# Access Compliance Report

## Public Rights-of-Way

### (Curb Ramps)

Intersection ID: 16578	Main Street: CONWAY_AV	Cross Street: SCALEYBARK_RD	Location: S
ADA ID: 41C072D9D360	Ramp Type: Directional1	Initial Pass/Fail: Fail	Overall Compliance: No
		Severity Score: 1.25

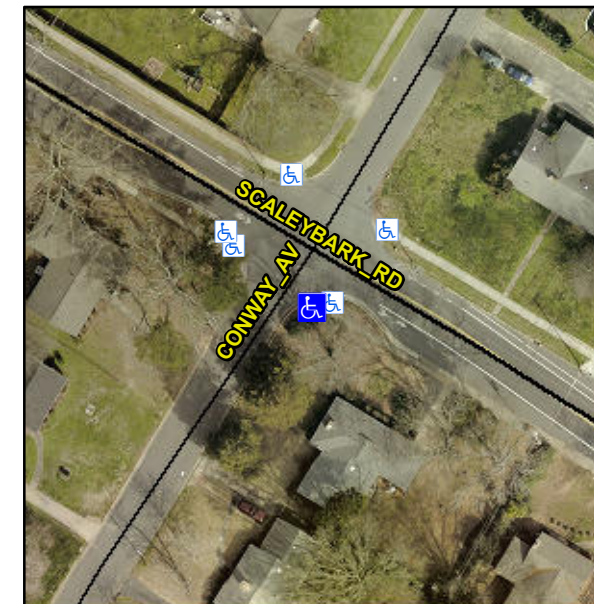
**R304.5.3**

Compliance	Description	Data	Compliance	Description	Data
N/A	Ramp Length (in)	49.0	N/A	Grade Break?	N/A
Yes	Ramp Width (in)	60.0	N/A	Grade Break Slope (%)	0.0
Yes	Ramp Slope (%)	4.2	N/A	Grade Break XSlope (%)	0.0
No	Ramp XSlope (%)	2.5			
N/A	Flare Type LT	N/A	N/A	Flare Type RT	N/A
N/A	Flare Slope LT (%)	N/A	N/A	Flare Slope RT (%)	0.0
N/A	Flare Traversable LT?	N/A	N/A	Flare Traversable RT?	N/A
N/A	Landing Length (in)	0.0	N/A	DWS Provided?	N/A
N/A	Landing Width (in)	0.0	N/A	DWS Contrast?	N/A
N/A	Landing Slope (%)	0.0	N/A	DWS Length (in)	N/A
N/A	Landing X Slope (%)	0.0	N/A	DWS Full Width?	N/A
N/A	Landing Curb? (Y/N)	N/A	N/A	DWS Offset LT (in)	N/A
N/A	Shared Landing?	N/A	N/A	DWS Offset RT (in)	N/A
N/A	Gutter Ponding?	0.0	N/A	Gutter Slope (%)	N/A
N/A	Gutter Lip Ht (in)	0.0	N/A	Gutter X Slope (%)	N/A
N/A	Painted X Walk1?	No		Road Slope (%)	2.8
	X Walk 1 Direction	To NW		Road X Slope (%)	4.2
	X Walk 1 Width (in)	N/A		Clear Space?	N/A

**Remove & Replace Entire Ramp.**
